ADDENDUM

RFB NO. 316044 - ADDENDUM NO. 1

PEDESTRIAN/SNOWMOBILE BRIDGE – WALKING IRON COUNTY PARK

MAZOMANIE, WISCONSIN

2. Sheet 1

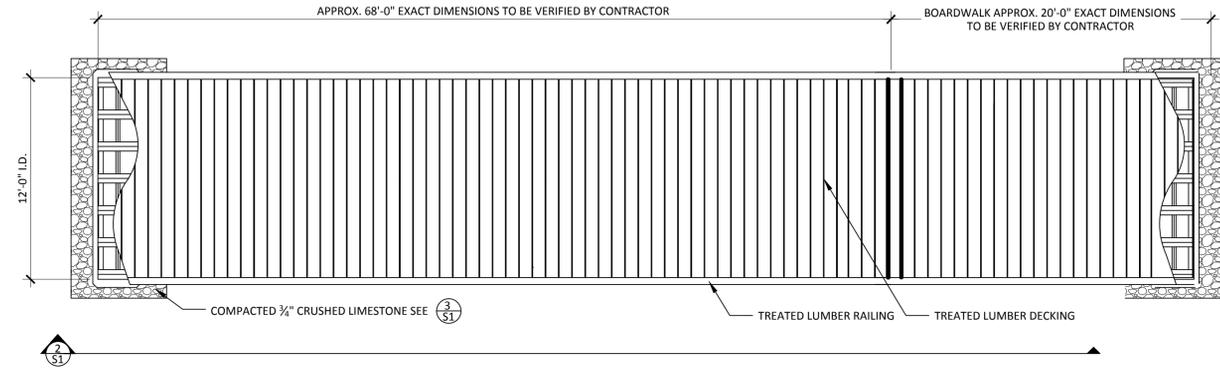
Delete current Sheet 1 – Bridge Plans, replace with new Sheet 1 dated 11/29/16, issued with this addendum.
